Access Compliance Report

Public Rights-of-Way

Intersection ID: 30327	Main Street: FLYING_SCOTSMAN_DR	Cross Street: STOURBRIDGE_LION_DR	Location: E
ADA ID: 68E95AB7158B	Ramp Type: PerpDiag	Initial Pass/Fail: Fail	Overall Compliance: No
		Severity Score: 21.25

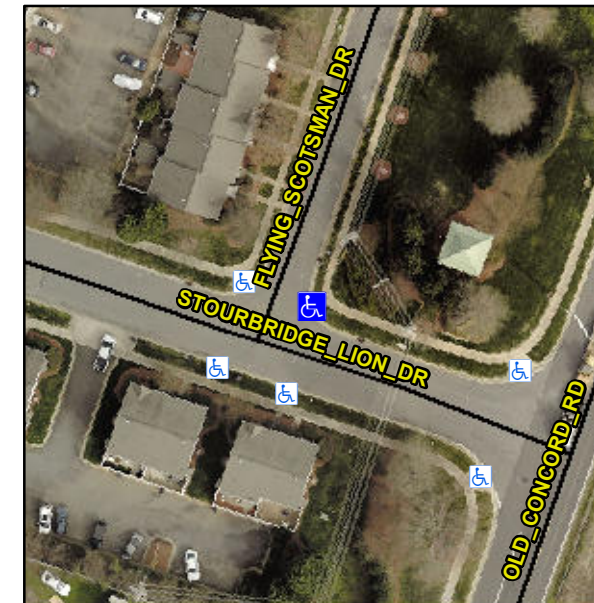
Not Found, R304.5.1, R304.2.2

Compliance	Description	Data	Compliance	Description	Data
N/A	Ramp Length (in)	70.0	No	Ramp Slope (%)	10.4
No	Ramp Width (in)	47.5	Yes	Ramp XSlope (%)	0.3
N/A	Flare Type LT	N/A	N/A	Flare Type RT	N/A
N/A	Flare Slope LT (%)	N/A	N/A	Flare Slope RT (%)	N/A
N/A	Flare Traversable LT?	N/A	N/A	Flare Traversable RT?	N/A
N/A	Landing Length (in)	N/A	N/A	DWS Provided?	N/A
N/A	Landing Width (in)	N/A	N/A	DWS Contrast?	N/A
N/A	Landing Slope (%)	N/A	N/A	DWS Length (in)	N/A
N/A	Landing X Slope (%)	N/A	N/A	DWS Full Width?	N/A
N/A	Landing Curb? (Y/N)	N/A	N/A	DWS Offset (in)	N/A
N/A	Shared Landing?	N/A			
N/A	Gutter Ponding?	N/A	N/A	Gutter Slope (%)	N/A
N/A	Gutter Lip Ht (in)	1.0	N/A	Gutter X Slope (%)	N/A
N/A	Painted X Walk1?	No	N/A	Painted X Walk2?	No
	X Walk 1 Direction	To NW		X Walk 2 Direction	To SW
N/A	X Walk 1 Width (in)	N/A	N/A	X Walk 2 Width (in)	N/A
	X Walk 1 Slope (%)	1.0		X Walk 2 Slope (%)	2.9
	X Walk 1 X Slope (%)	1.3		X Walk 2 X Slope (%)	2.2

Remove & Replace Curb Ramp With Two New Directional Ramps or Equivalent.
